Submissions Report

The HumeLink Project – Material change in circumstance assessment

8 June 2024

These benefits are illustrated in the following diagram from the EY Market Modelling Report (Modelled REZ capacity mix difference between Option 3C and Base Case in the Step Change scenario – Figure 14).

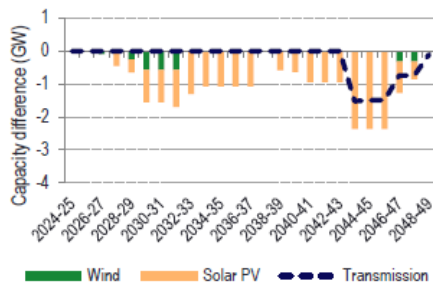
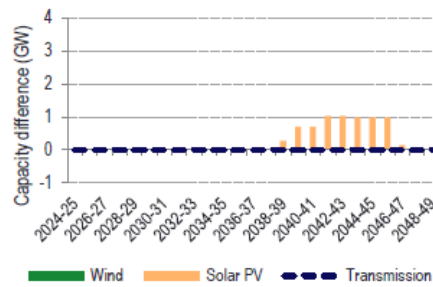
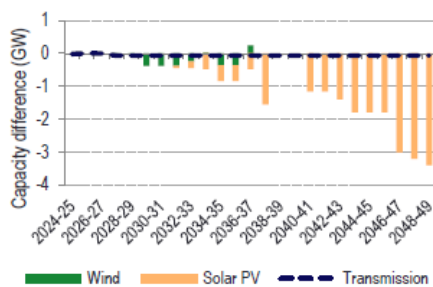
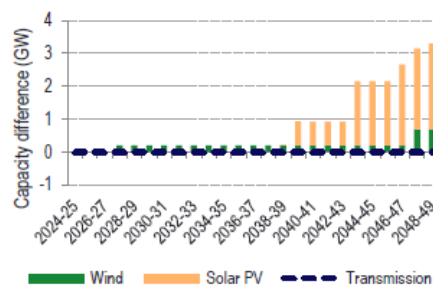
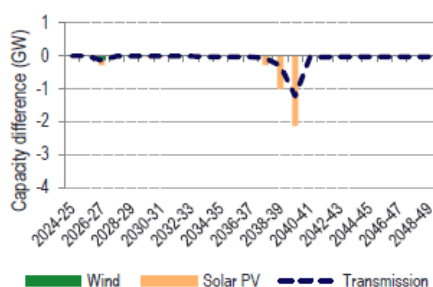
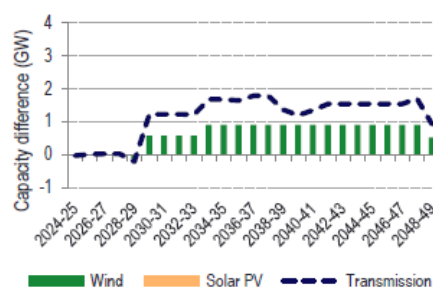
- Why is the EY gross benefits estimate higher than AEMO's draft 2024 ISP assessment?
- Is it appropriate to assume a wind drought in 2029/30, which is seen to increase benefits?

In computing this estimate, EY aligned as many input assumptions as possible with the Draft ISP 2024 and followed a similar methodology. Any known differences in input assumptions and methodology are noted in the EY Market Modelling Report¹, Section 7.

Market modelling for an ISP focuses on cost efficient transmission network development over the long term. One difference is that, whereas AEMO used a 4-node model of NSW network in the Draft ISP 2024, EY used a 9-node model, which identified greater market benefits from the HumeLink Project. Specifically, that HumeLink supports more cost-efficient investment in renewables, enabling more low-cost capacity build away from Central-West Orana and New England, as well as enabling more higher capacity factor wind capacity build in Victoria through the improved connection via VNI West.

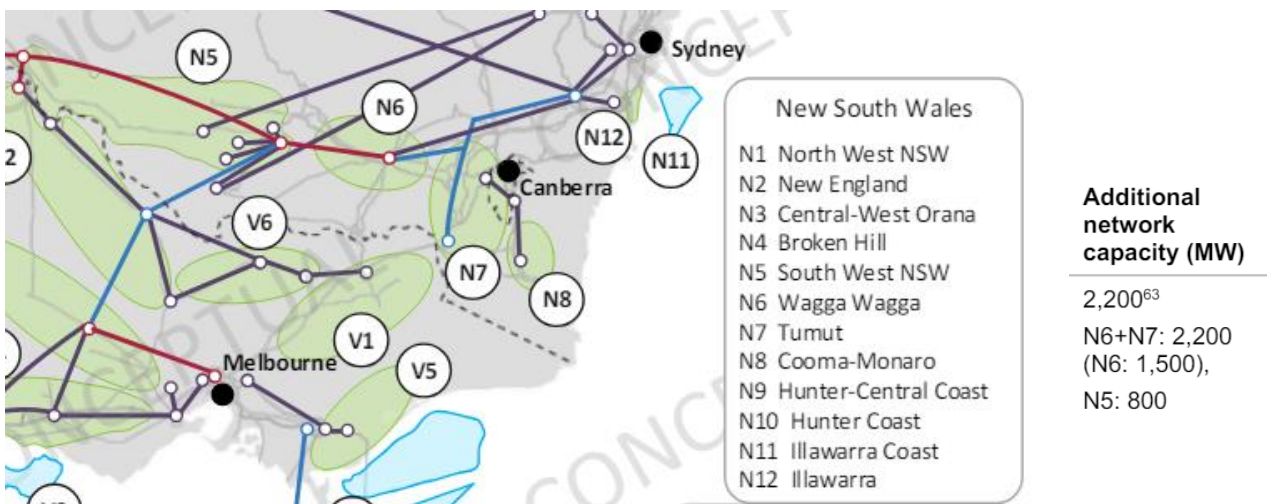
Some submissions ask whether the proposed 2,200 MW capacity of HumeLink will be able to achieve all of the following three objectives:

1. connect Snowy 2.0 (2,200 MW)
2. connect renewable generation in southern NSW (4,300 MW)
3. increase the capacity for interstate transfers between NSW, Victoria and South Australia (2,735 MW).

Submissions ask that, given these three objectives total 9,235 MW in capacity requirements, why a larger capacity HumeLink option has not been considered.

The Draft 2024 ISP considered network augmentation options with higher network capacity for HumeLink. However, these options are not selected in the optimal development path, which is created using market modelling tools that use forecasted demand and generation traces to develop an optimal network to maintain prescribed system adequacy and reliability. A higher capacity for HumeLink would represent over investment and result in fewer or negative net market benefits.

The differing numbers cited in the submissions all refer to different aspects of capacity that will be augmented by HumeLink.

- **2,200 MW** is the capacity of energy delivered towards Sydney across the existing and new 500 kV HumeLink line to Bannaby. In AEMO's 2023 Transmission Expansion Options Report,² the increase in maximum flow capability between Central NSW (CNSW) and Sydney Wollongong Newcastle (SNW) regions provide by HumeLink is 2,200 MW (defined by CNSW-SNW cut-set limit). In the EY Market Modelling Report, the increase in the Canberra/YASS-Bannaby cut set limit provided by HumeLink is also 2,200 MW.
- **2,735 MW** is the increase in capacity provided by VNI West and Project Energy Connect.

HumeLink does not need a higher capacity because, although the generation capacity that can be installed in Southern NSW or can be transferred from VIC and SA is higher than 3GW, not all the generators will generate their maximum output at the same time.

Before the 500 kV HumeLink lines are connected, Snowy 2.0 will be connected to the existing 330 kV network by cutting into Line 64 as per the following diagram.

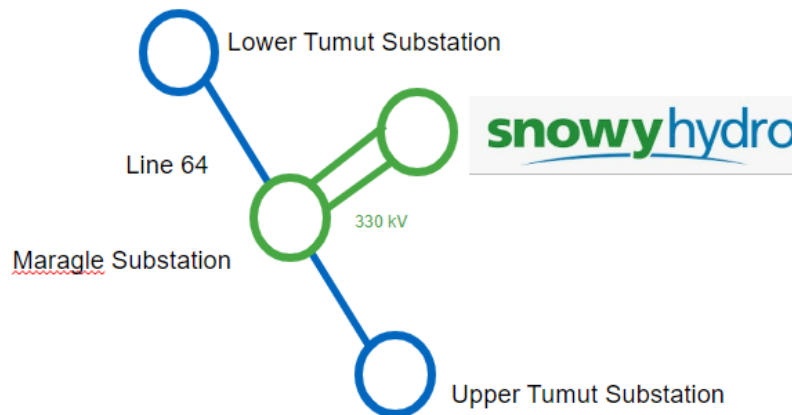
They also ask about the assumption, made by both Transgrid and AEMO, of a 660 MW export constraint on Snowy 2.0 should HumeLink not be finished at the time of Snowy 2.0 completion. Noting that the 660 MW export constraint on Snowy 2.0 appears to have a significant impact on the market benefits estimate, submissions ask for more information about how the 660 MW export constraint was derived.

Line 64 has a thermal limitation to cater for the N-1 contingency (a trip of the line either from Upper Tumut to Maragle or Lower Tumut to Maragle). Given the 330 kV Line 64 has a Summer Day normal rating of 714 MVA and a 15-minute rating of 857 MVA, only two units of Snowy 2.0 generators can be commissioned until HumeLink is complete.

Commissioning three units at full capacity would exceed the thermal line rating. With just two units commissioned, Snowy 2.0 generation capacity will be capped at either 667 MW (as per the connection application received by Transgrid for 2,000 MW output consisting of 6 units, each rated at 333.3 MW)³ or 732 MW (as per the latest information available on Snowy Hydro & AEMO website for 2,200 MW output consisting of 6 units, each rated at 366.7 MW) under an optimistic scenario.

Considering the current utilisation of Line 64 (including existing Snowy generation) as well as thermal and potential stability limitations, Snowy 2.0 is expected to frequently operate at a lower dispatchable power level if commissioning occurs before HumeLink is complete.
